**RE: Replacement of 3.0-Million Gallon Raw Water Reservoir
AECOM Project No. 60744999**

ADDENDUM NO. 2 – February 6, 2026

RAW WATER RESERVOIR PLAN & SECTIONS

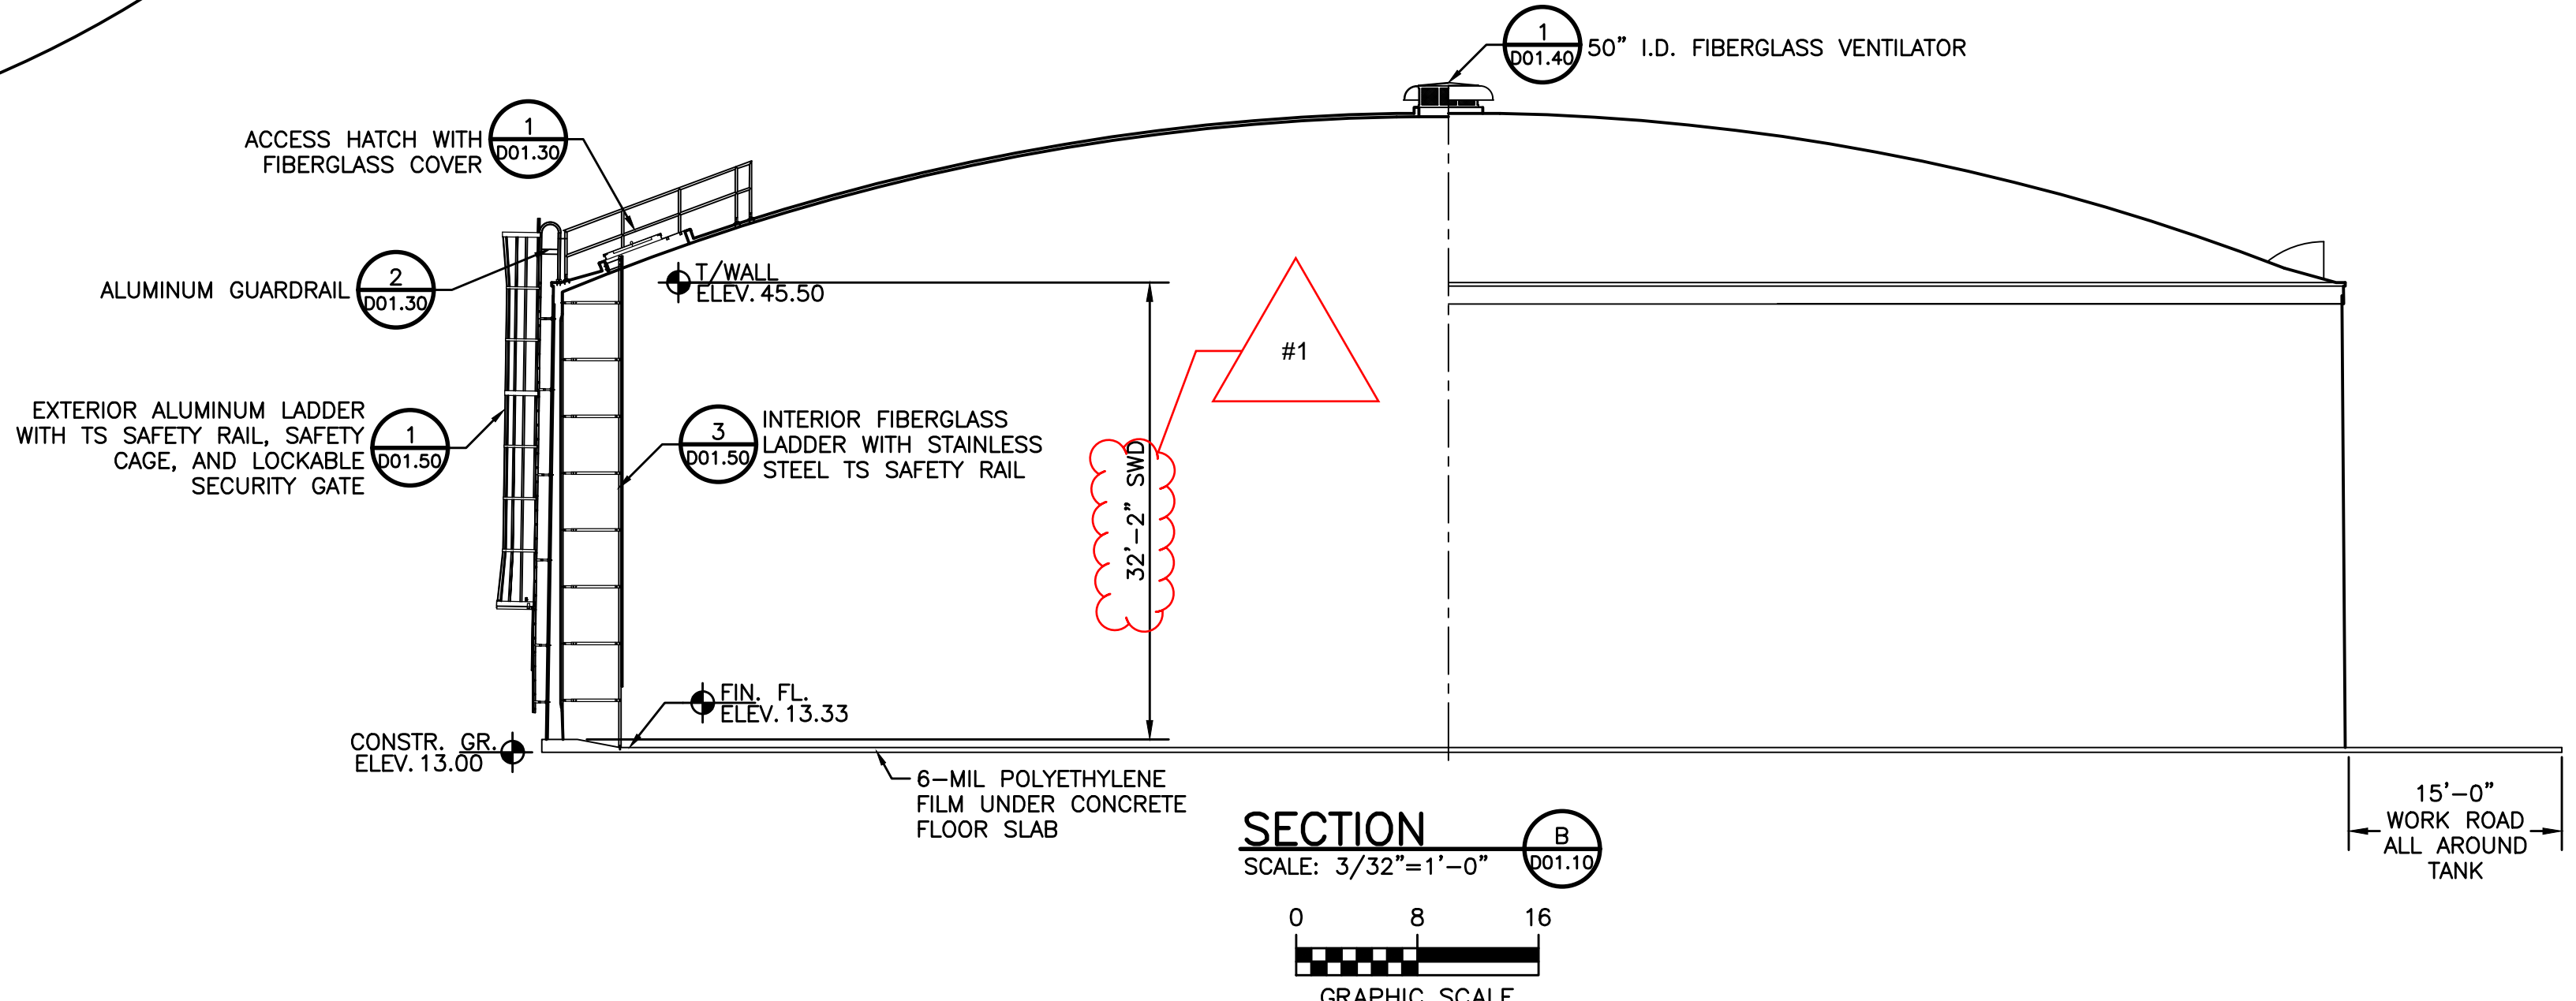
1. **Drawing D01.10** - Section view A wall height changed from 32'-9" to 32'-2".
2. **Drawing D02.20** – 12" Overflow Section additional pipe supports added.
3. **Drawing D02.20** – 12" Overflow Section HWL modified to 46.08, from 46.33 to eliminate water encroachment on dome roofs.

12. Plan Drawing D01.10 Section view A: The wall height is shown to be 32'-9". Please modify this dimension to be 32'-2" as the footer rises from the FFE is roughly 7".

13. Plan Drawing D02.20: The 12" DIP OVERFLOW SECTION view shows 2 pipe supports. Supports are typically provided every 12'-15' of vertical pipe length. Please confirm quantity of supports required and modify drawing if changed.

14. Plan Drawing D02.20: The 12" DIP OVERFLOW SECTION view shows the HWL elevation at 46.33. Please modify this HWL such that the HWL water does not encroach onto the dome overflows base elevation of 46.33 and remains at least 3" below the bottom base elevation of the dome overflows. This will avoid any spillage out of the dome overflows under normal operating conditions. In addition, this adequate confirm maximum flow from plant will also not cause the water line to rise to 46.33 under normal operating conditions.

Revised

Revised

Revised
